# John Wood

## **SAFETY RECALL**

Subject: John Wood Oil-Fired Residential Water Heaters, Model Nos. JW517 (50 gallon) & JW717 (70 gallon) (in serial number ranges described below)

Insertion depth in this example is 8.7”.

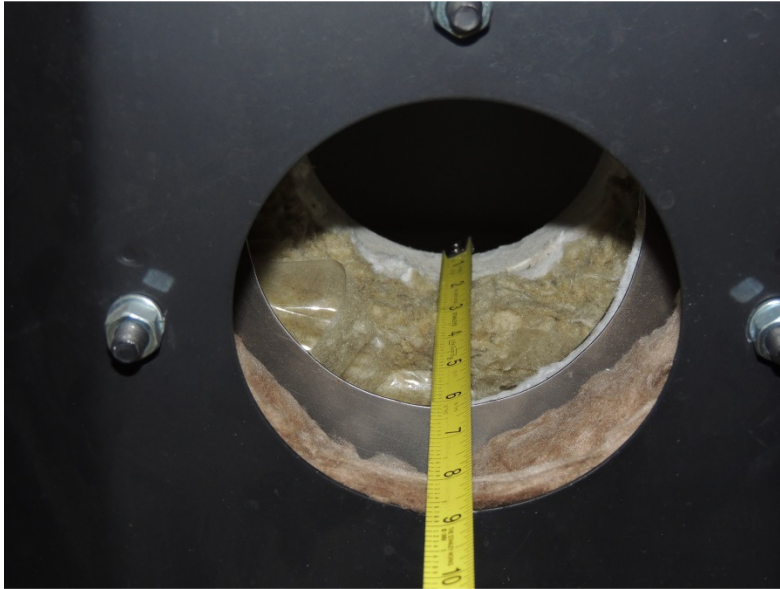
The Issue: The "insertion depth" (the distance from the outer jacket to the interior combustion chamber) on the affected water heaters may in some instances be longer than the 7-8 inch tolerance. In addition, a subset of the affected JW517 units may have inverted radiation shields. Any unit with either an inverted radiation shield or an insertion depth shorter than seven inches or longer than eight inches should be inspected to determine if it should be retrofitted or replaced.

- Provide you with a free replacement water heater for each unit with an inverted radiation shield: model JW517, serial range 1349A021678 to 1429A013935.
- For all other units subject to this recall, we will dispatch a service agent to make an on-site inspection of your water heater. If it needs to be replaced, we will provide you with a replacement water heater free of charge.
